## Top Flite B-25 Mitchell ARF Product Improvement

*Please refer to this addendum when you get to the steps in the instruction manual noted below.*

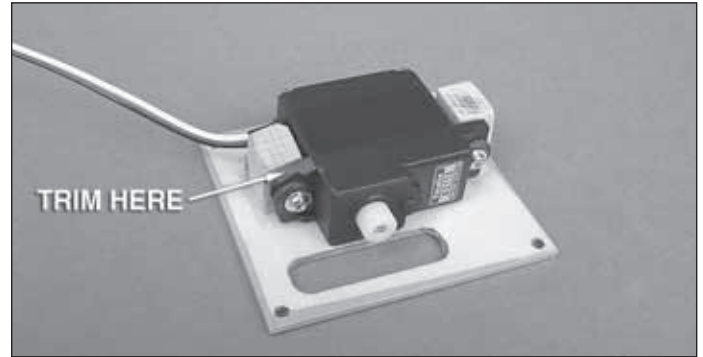
Perform this step after step 2 on page 25:

After mounting the rudder servos to the hatches, trim the front mounting tab of both servos as shown so they fit in the hatch without contacting the top sheeting inside.
